Subject: Response to Request for Additional Information (RAI) for Volume 2 of  
Surface Impoundment Decommissioning Plan (TACL32759)

**REQUEST FOR ADDITIONAL INFORMATION REGARDING  
HONEYWELL METROPOLIS WORKS LICENSE AMENDMENT  
REQUEST REPORT FOR CLOSURE OF SURFACE IMPOUNDMENT  
PONDS B, C, D AND E, VOLUME 2, June 2012**

**FIGURE 2A**  
**CROSS-SECTION A-A**  
**HONEYWELL - METROPOLIS WORKS FACILITY**  
**METROPOLIS, ILLINOIS**

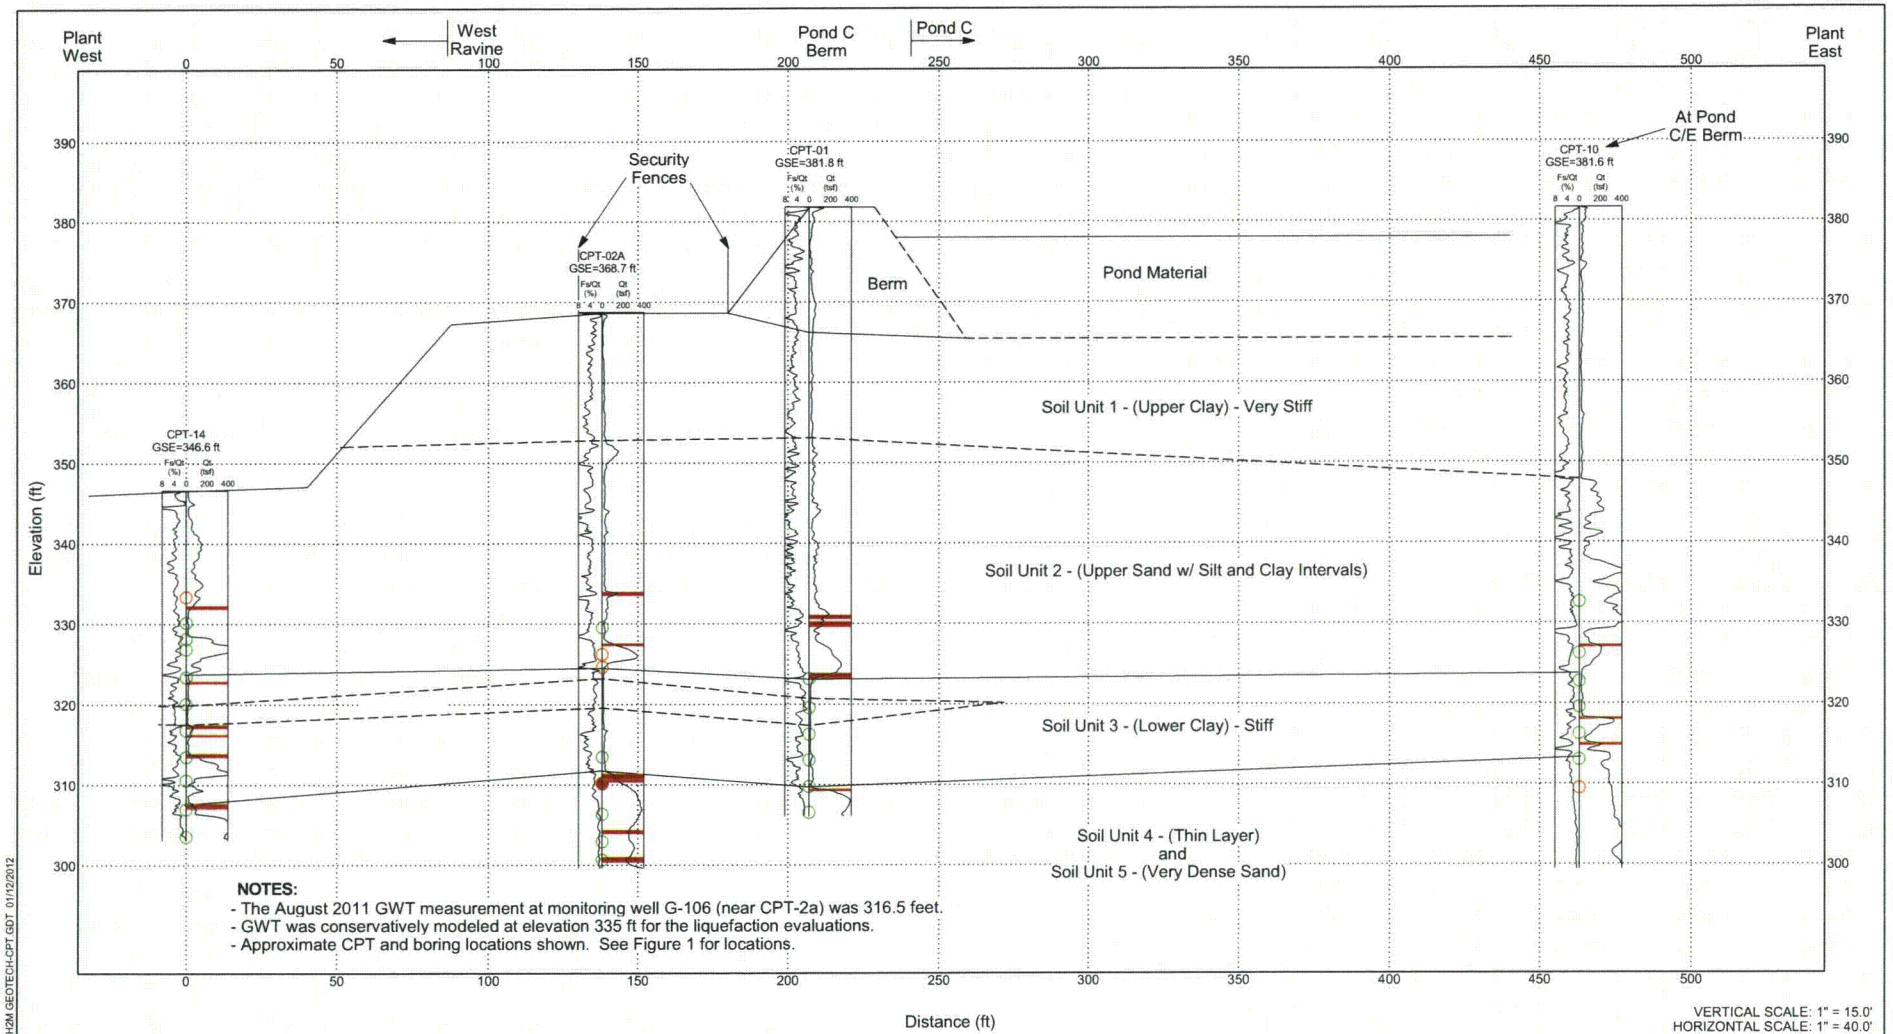
*The staff is concerned about how liquefaction of Soil Unit 4 could negatively affect the stability of the erosion protection system. Thus, the staff requests the licensee to explain when and where the new borings will be drilled.*

- Laterally continuous, found at most of the investigation locations near the critical ravine slopes (i.e., CPT-1, 2a, 3, 4, 5, 14, and 15, and borings GT-03, 04, and 05).
- Thickness of only a few inches to a few feet. This is thinner than that modeled in the LARR, Volume 2 (approximately 10 feet).
- Liquefied shear strength ratio ( $S_u/P'$ ) of 0.32, based on the average of various methods for correlating CPT tip resistance and SPT blowcount to liquefied shear strength ratio. This  $S_u/P'$  is between the values for the “partially liquefied” and “fully liquefied” conditions presented in Section 3.4 of the LARR, Volume 2 (0.42 and 0.17, respectively).

As shown on the cross sections in Attachment 1, the CPT soundings and borings also identified a thin interval within Soil Unit 3 (lower clay)—designated as Soil Unit 3a herein—that has relatively lower strength than the surrounding Soil Unit 3. Based on the field data and laboratory testing, Soil Unit 3a has an  $S_u/P'$  of 0.27 to 0.32, similar to Soil Unit 4.
